SERVICE BULLETIN

M-894

PRODUCTION CHANGES ON XL TRANSMISSION COVER AND ALTERNATOR STATOR MOUNTING

Figure 1. Transmission Cover Assembly

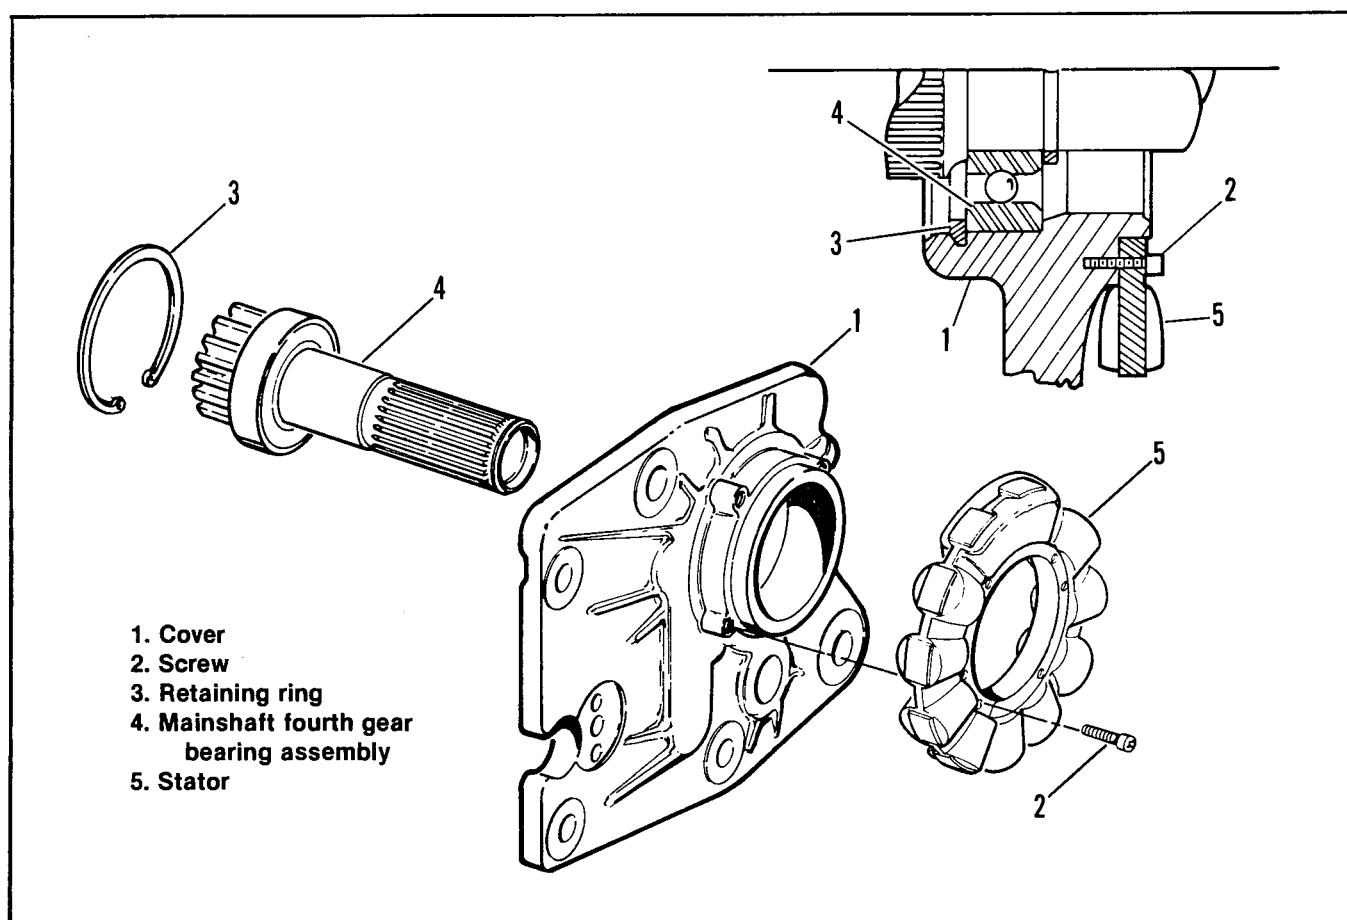
On XL model vehicles, starting with crankcase #785 208 001, manufactured after July 26, 1984, there have been several improvements on the method of retaining the mainshaft fourth gear/bearing assembly and the means of attaching the alternator stator to the transmission access cover. The mainshaft fourth gear/bearing assembly is now retained between a shoulder within the transmission cover bore, at one side, and a retaining ring at the opposite side. The beveled retaining ring is installed with the beveled side facing the transmission and the flat side next to the bearing.

The stator (5) is now attached directly to the door (1) by four torx locking screws (2). The torx screws are installed to a torque value of 30-40 in-lbs.

Figure 2. Stator Mounting Holes

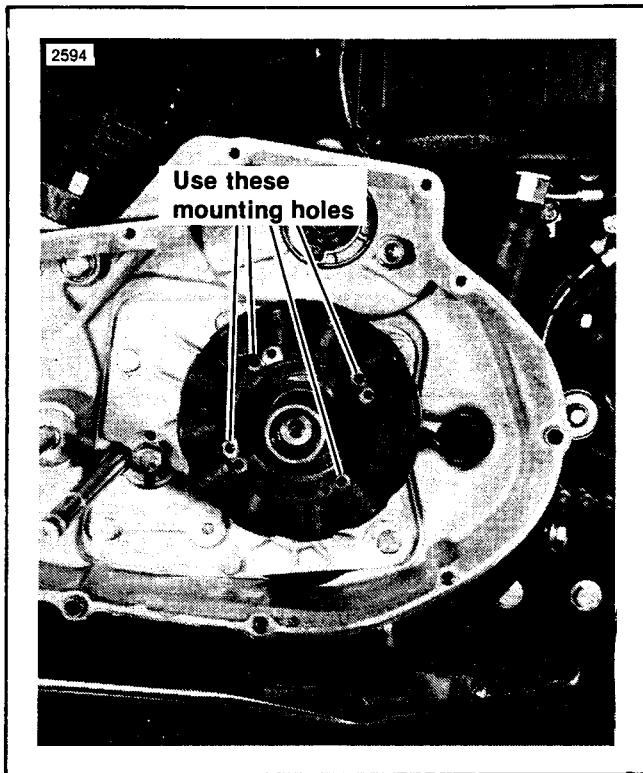
Those alternator stators with eight mounting holes must utilize the proper holes as indicated in Figure 2. This will prevent possible chafing of the stator wire leads.
